Tuck O'Brien
City Planning Director, Planning Division

Re: 48 Hancock Street – Project Number 2015-00033

The Hawk SOE

REVISED SITE PLAN
MAY 19, 2016

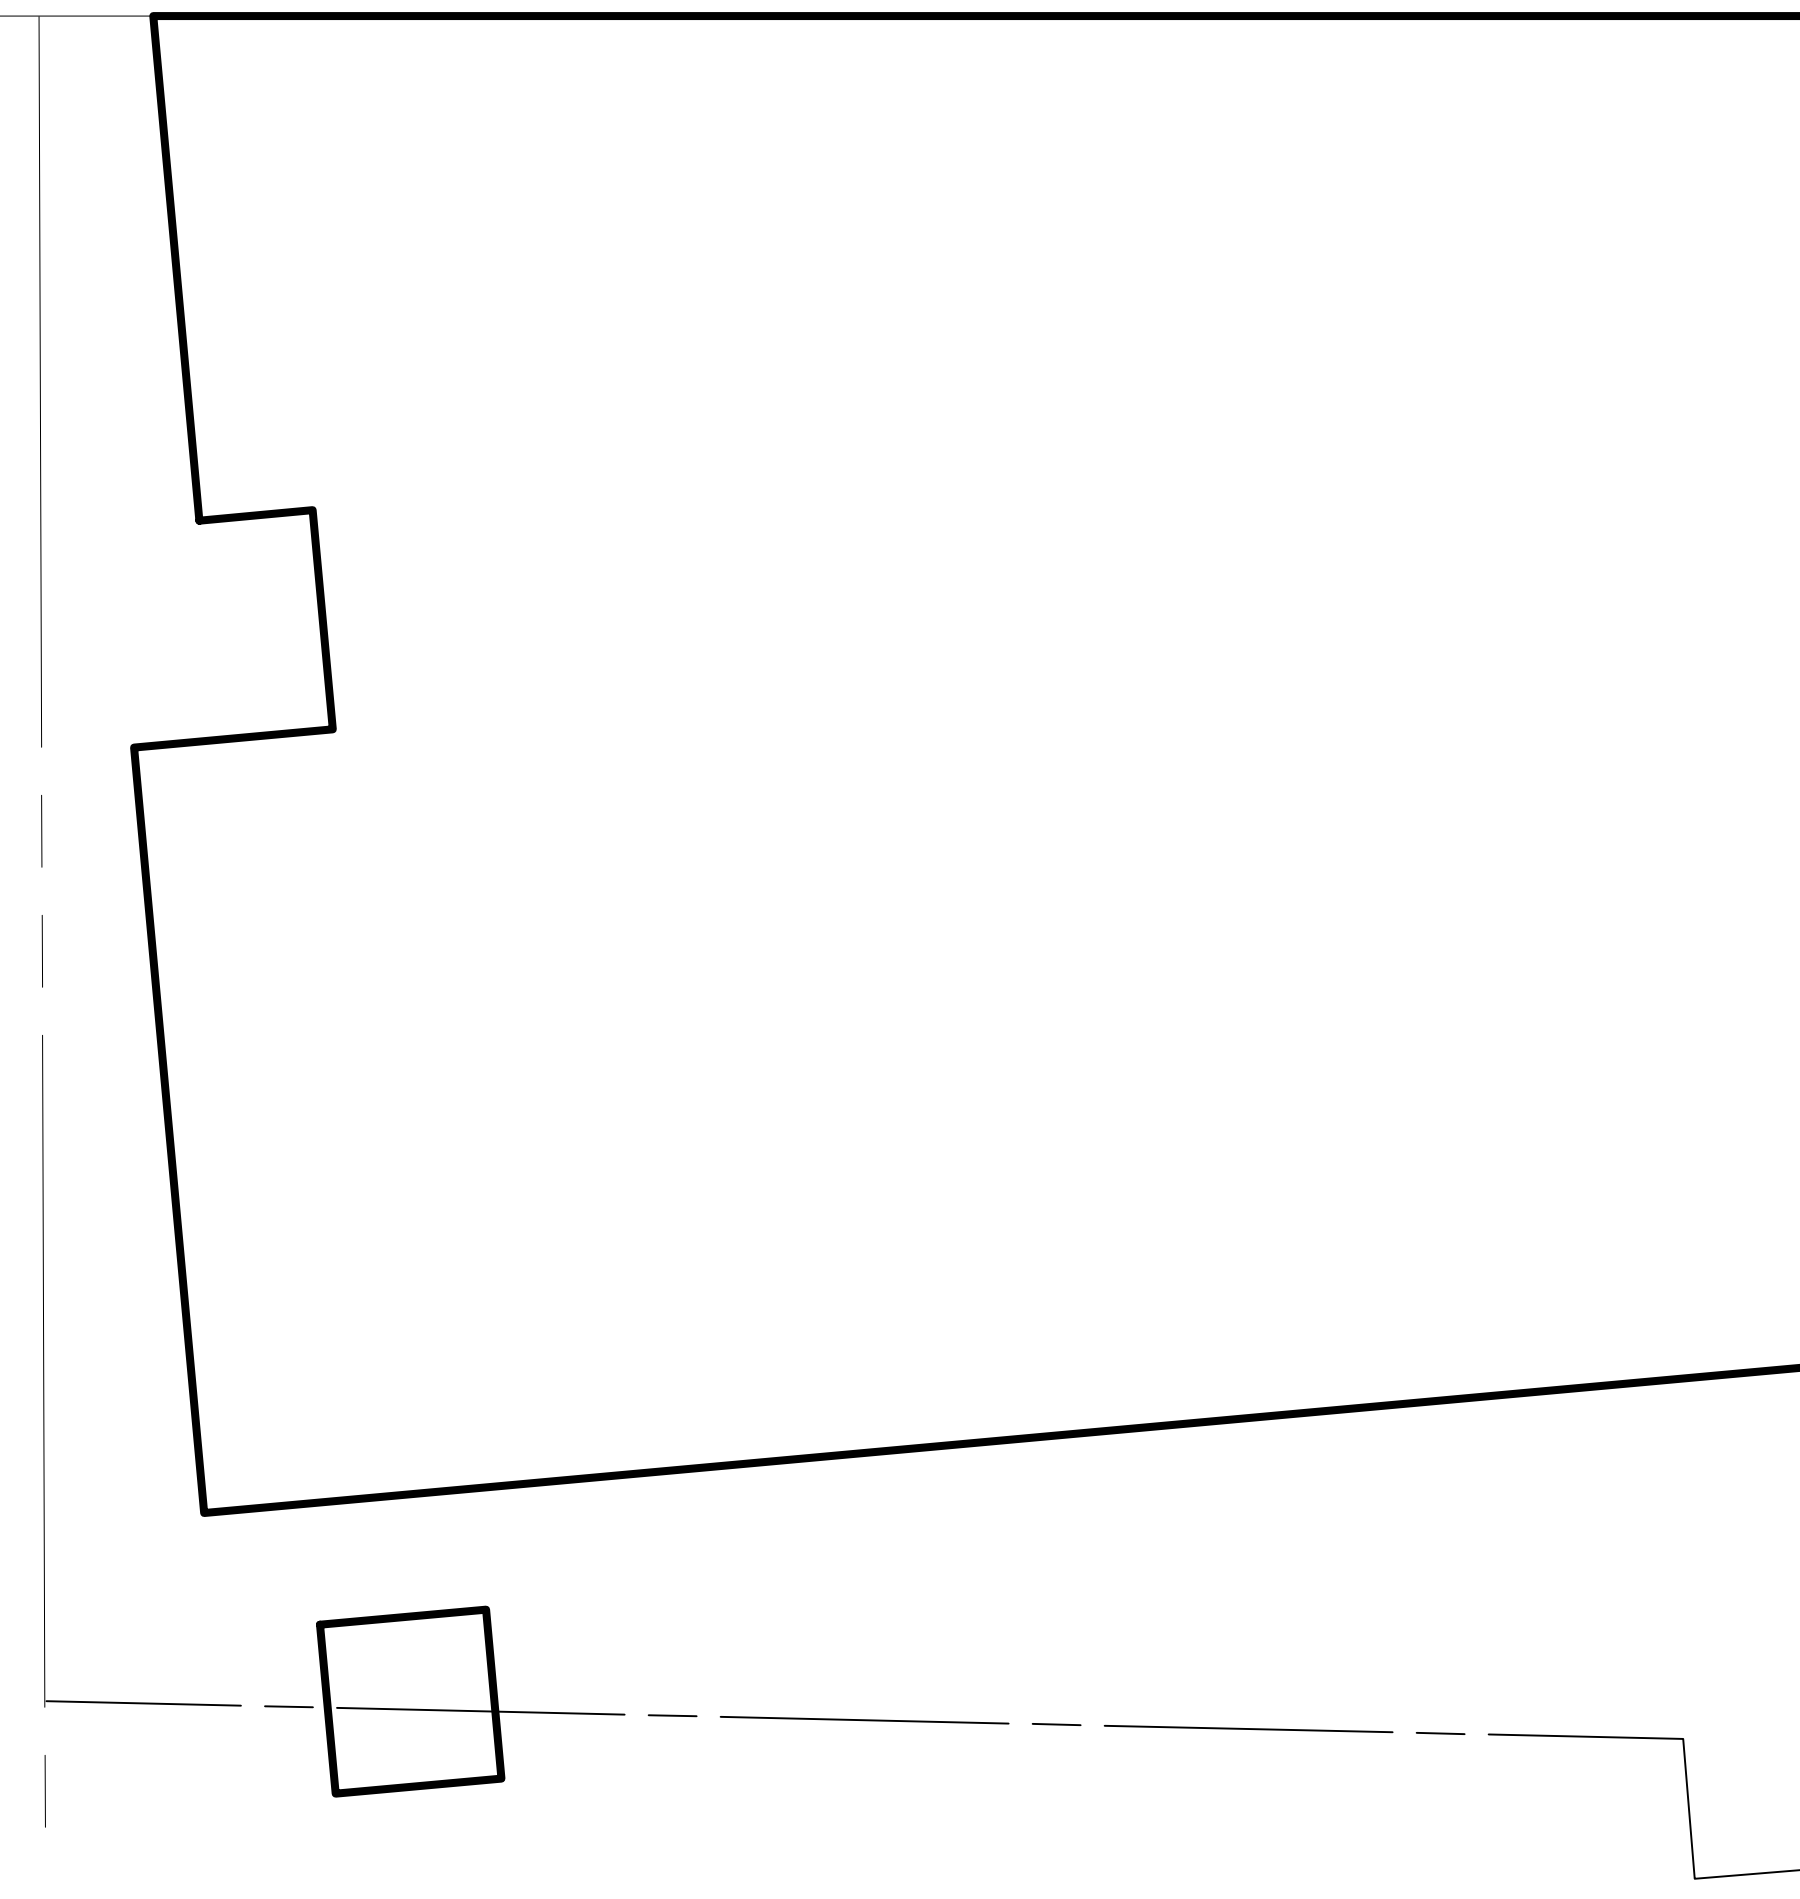
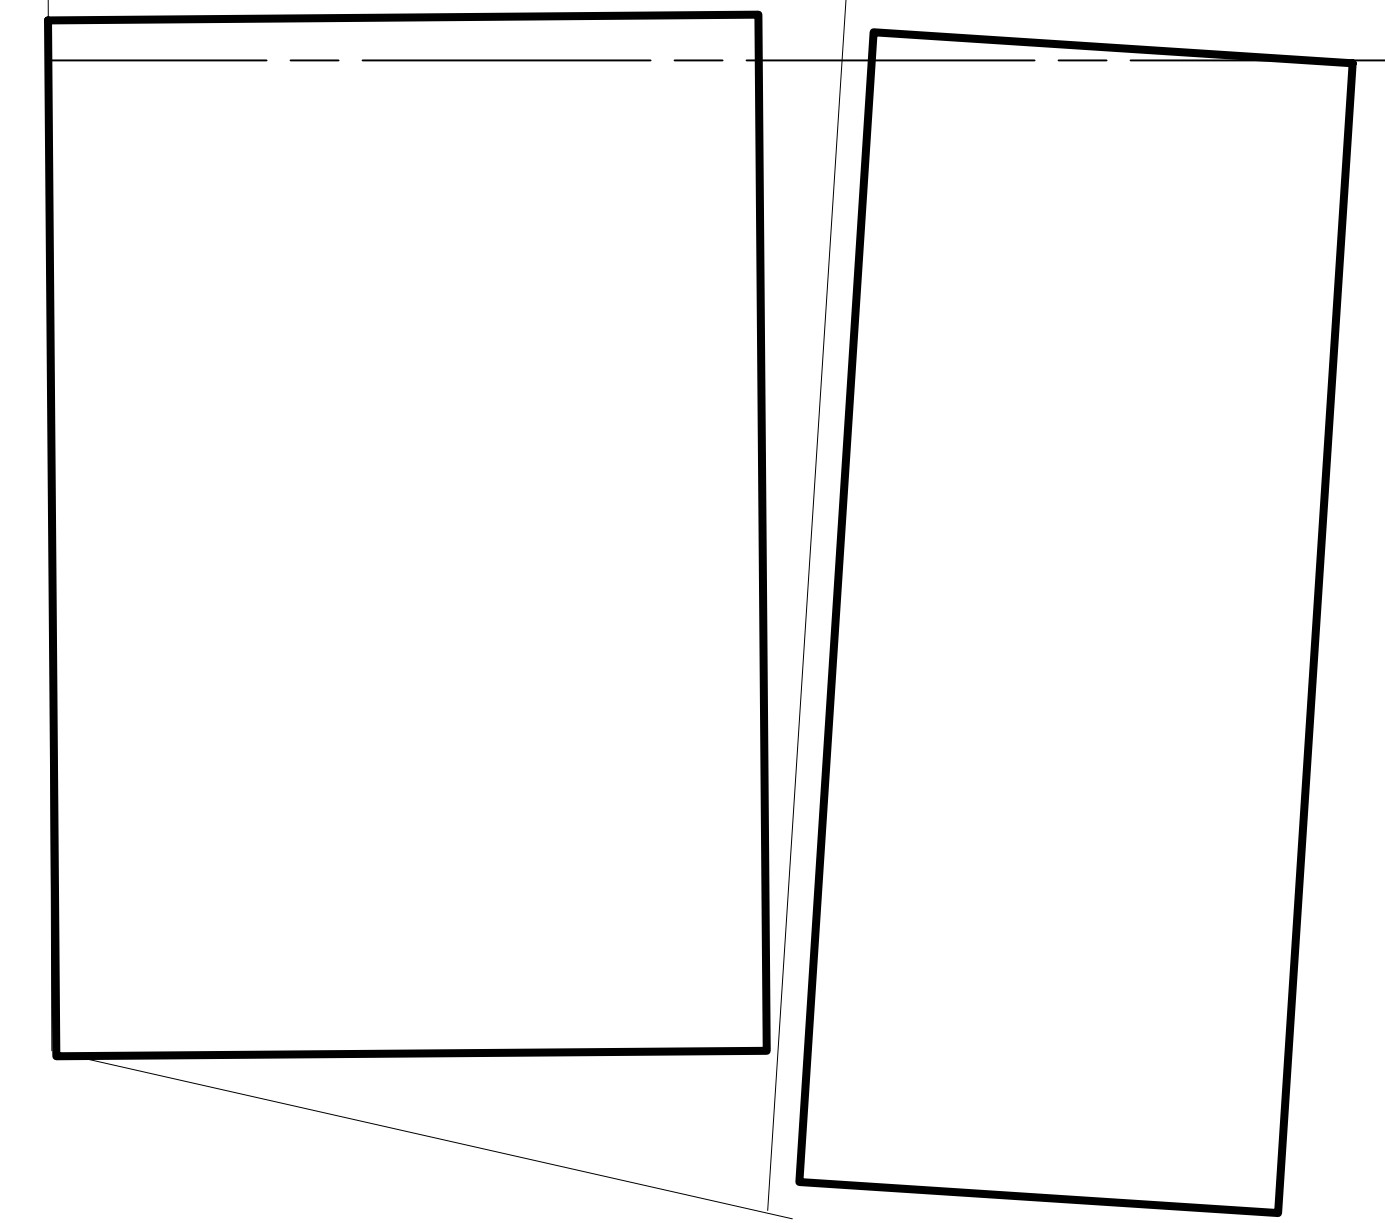
2. Please show the location of the proposed SOE system on the site plan, as we seek to confirm the work is within the site's boundaries.

Attached

Based on our existing survey plan and a recent survey confirming pin location and any discrepancies, we can confirm, with this information all work will be within our property lines. Please be advised that we have not been made aware of any disputes regarding our survey plan to date.
